MONTGOMERY COUNTY HISTORIC PRESERVATION COMMISSION
STAFF REPORT

Address:	5813 Surrey St., Chevy Chase	Meeting Date:	3/27/2019
Resource:	Secondary (Post-1915) Resource (Somerset Historic District)	Report Date:	3/20/2019
Applicant:	Dan & Aviva Rosenthal (Tahani Share, Architect)	Public Notice:	3/13/2019
Review:	HAWP	Tax Credit:	N/A
Case Number:	35/36-19C	Staff:	Michael Kyne

PROPOSAL: **RETROACTIVE** site alterations and retaining wall removal

Fig. 2: As-built/unapproved driveway dimensions, as measured and prepared by staff.

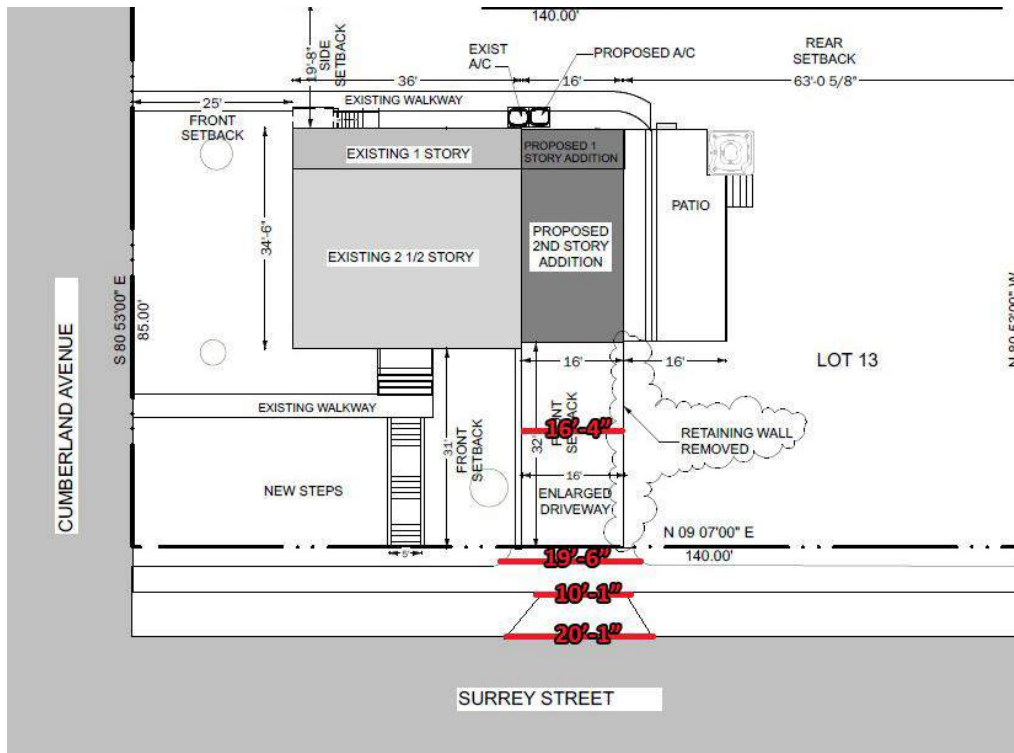
According to the current application, the driveway has been enlarged to the approved 16'; however, staff visited the subject property on March 19, 2019 to measure the driveway and found the following:

- The new driveway apron is flared and measures 20'-1" adjacent to Surrey Street, reducing to 10'-1" at the sidewalk, with an additional 9" to 20" flagstone on dirt border at the right (south) side of the apron.
- The new driveway measures 19'-6" at the sidewalk, reducing to 16'-4" as it approaches the house, with an additional 9" to 19" flagstone on dirt border at the right (south) side of the driveway.

As the Commission previously found, the existing driveway (and apron) is incompatible with character of the subject property, the surrounding streetscape, and the historic district, where it exceeds 16’.

- Alterations to the unapproved/as-built driveway, with the revised driveway (including apron) not exceeding 16' at any point.
- Replacement of the retaining wall at the left (north) side of the driveway, with all dimensions and materials of the previously removed retaining wall and the new retaining wall specified.
- Replacement/construction of a matching retaining wall at the right (south) side of the driveway.

Fig. 5: Approved front elevation, showing proposed driveway, retaining walls, and grading.

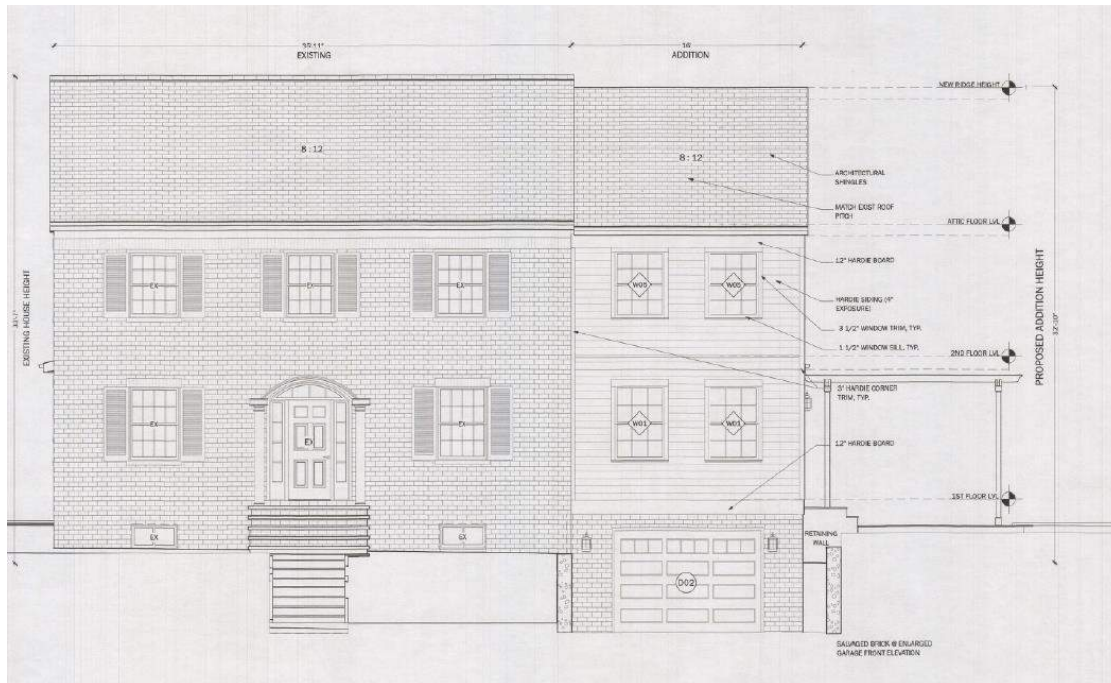
Throughout the entire process – from the first preliminary consultation to the Staff Item Revision – the proposed driveway enlargement included the relocation of the existing retaining wall on the right (south) side of the driveway and preservation of the consistent grading on both sides of the driveway. The proposal did not call for removal or replacement of the retaining wall on either side of the driveway; however, the right (south) side retaining wall has been removed and the front/right (southwest) side of the property has been significantly regraded. The result is inconsistent grading on either side of the driveway. This is incompatible with the character of the streetscape along Surrey Street, where the existing hardscaping – for both front walkways and driveways – is bound by consistent grading on either side. This is also incompatible with the historic character of the subject property, where the driveway was clearly delineated by the retaining walls and bound by consistent grading on either side.

Altering the grade in this manner has also resulted in nearly 8’ of exposed concrete foundation wall for the new patio, which directly faces Surrey Street (See *Figures 4 and 6*). The approved drawings (*Figure 5*) showed at most 18” to 2’ of exposed concrete wall for the patio. Flattening out the grade in this large section of the front and side yard has two negative consequences: 1) it has altered the consistent grading and character of the landscape of the historic property, which are character defining features; and 2) the now exposed 8’ high by 16’ wide concrete foundation has altered the appearance of the previously approved patio addition to such a large degree that the patio is of questionable compatibility with the historic house.

- Backfilling the front/right (southwest) side of the property, restoring the grade and thus the amount of exposed foundation wall on the patio to its previously approved condition.
- Partial removal and alteration of the rear (east) walkway, with the incompatible gravel expansions removed from the proposal.
- Revisions to the approved right (south) side patio, with all revisions (i.e., additional steps, design changes, railing installation, etc.) clearly specified.
- Installation of a metal handrail at the right (south) side of the new front steps/walkway, with all materials and dimensions specified.

Fig. 7: Approved patio.

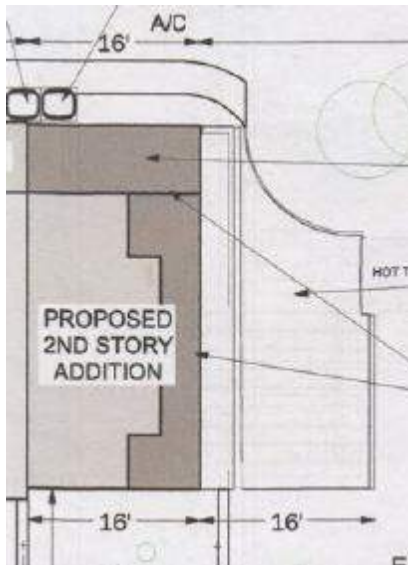
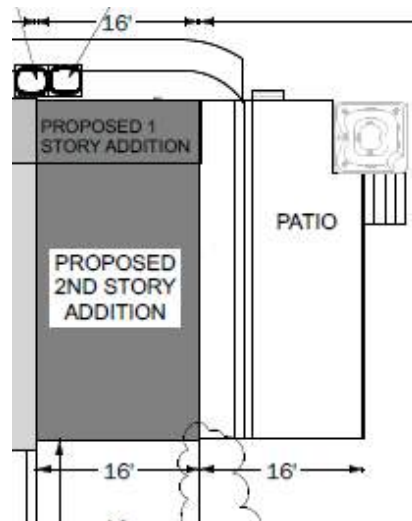
Staff has also compared the approved and as-built site plans and found that the footprint of the as-built right (south) side patio has slightly increased. Whereas the rear (east) edge of the patio was curvilinear in the approved site plan, the as-built patio is rectilinear. As depicted in staff's photograph below, a high-tension cable railing has also been installed on the patio. This was not reviewed or approved by the HPC and was likely added to satisfy code requirements, since the unapproved grade changes at the front/right (southwest) side of the property increased the height of the patio to more than 36", and the approved patio was at grade. An additional step has been added from the house to the patio, and three steps have been added from the patio to grade. The applicants' approval also called for a pergola to be constructed on the patio, which has not been completed. The proposed patio revisions are generally compatible, but they have not been approved and are currently in violation of the applicants approved HAWP.

Fig. 11: Approved site plan.

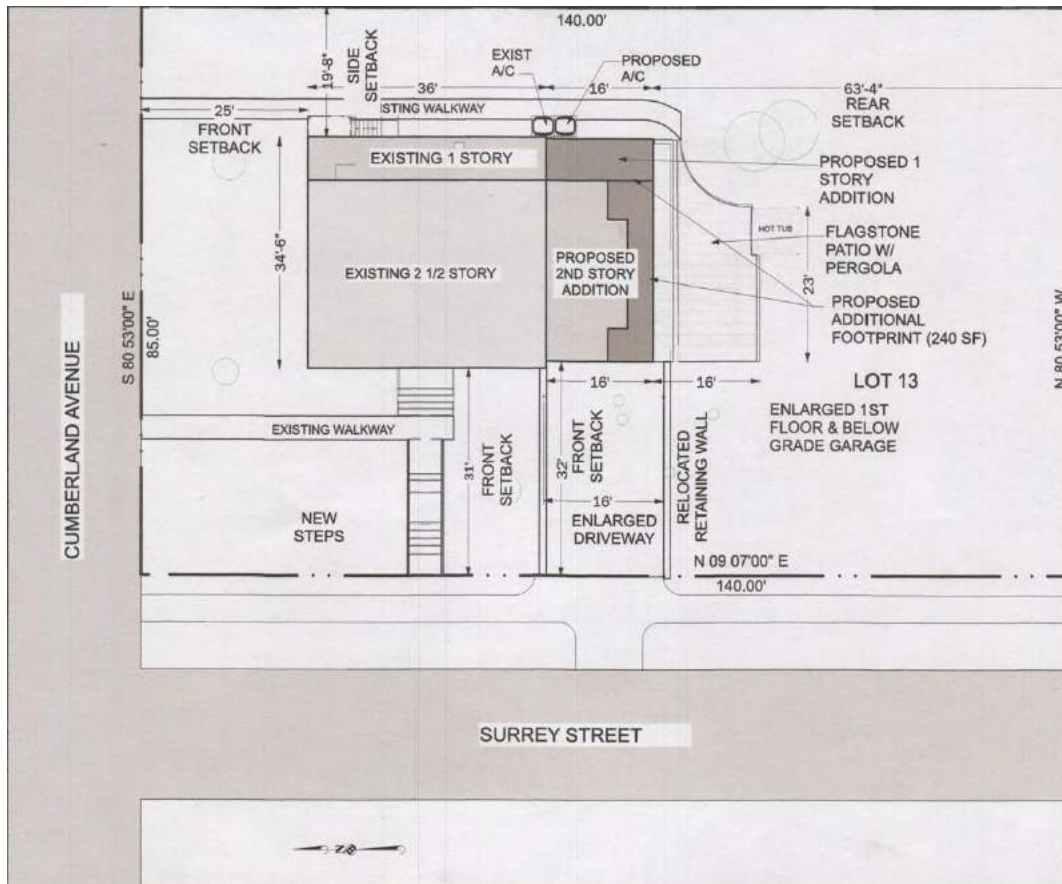
During staff's March 19, 2019 site visit, staff also found that the walkway at the rear (east) of the house has been altered without the HPC's approval. The southernmost part of the walkway has been removed, and the northernmost part has been replaced and altered. A landing has been added at the rear (east) entry to the house and a gravel expansion bordered by railroad ties has been added to either side of the walkway where it meets the sidewalk along Cumberland Avenue. While the walkway alterations are generally compatible, the gravel expansions on either side of the walkway where it meets Cumberland Avenue make the width of the walkway inconsistent with the surrounding streetscape and with the historic district, where the average walkway is 5' wide or less.
